Environment and Sustainability Committee - Tuesday, 27 February 2024

Title	Summary of the River Thames Scheme (RTS) Statutory Consultation Project Group's Response (February 2024)
Purpose of the report	To make a decision
Report Author	Claire Sorrin Project Manager (Stantec) – Project Group Kelly Walker – Principal Planning Officer Kiran Boparai – Planning Officer
Ward(s) Affected	All Wards
Exempt	No
Exemption Reason	N/A
Corporate Priority	Community Environment
Recommendations	Committee is asked to: Agree the report and Appendix A
Reason for Recommendation	 This report is providing an update on the River Thames Scheme Statutory Consultation and the Project Group's draft response. To agree the Council's response to the Statutory Consultation

River Thames Scheme

Summary of the Project Group's Response to Statutory Consultation

Figure 4.1 Map of Ferris Meadow area with TPO's in yellow.

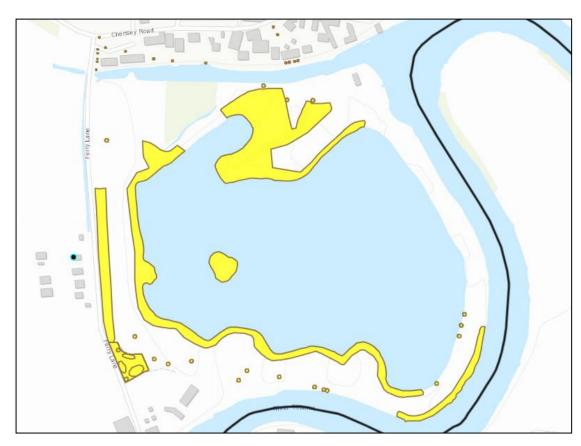
4.2.19 The Consultation presents seven options for the channel route at Ferris Meadow Lake, which has previously been presented to the Project Group (20th November 2023). In assessing these options, the Project Group would need to consider the visual impact, impact on protected trees, contamination issues and water quality of the lake. Based on the limited information and lack of

details, submitted to date, the Project Group is not able to indicate the preferred option(s) at this stage. It would be beneficial to see the detail and the various assessment outcomes to undertake an informed review prior to any decision being made. In addition, the development of this area would be of concern given that the lake side is covered by a large number of trees (see Figure 4.1 below) which are protected by Tree Preservation Orders (TPO's) and the area to the west of the lake is known landfill.
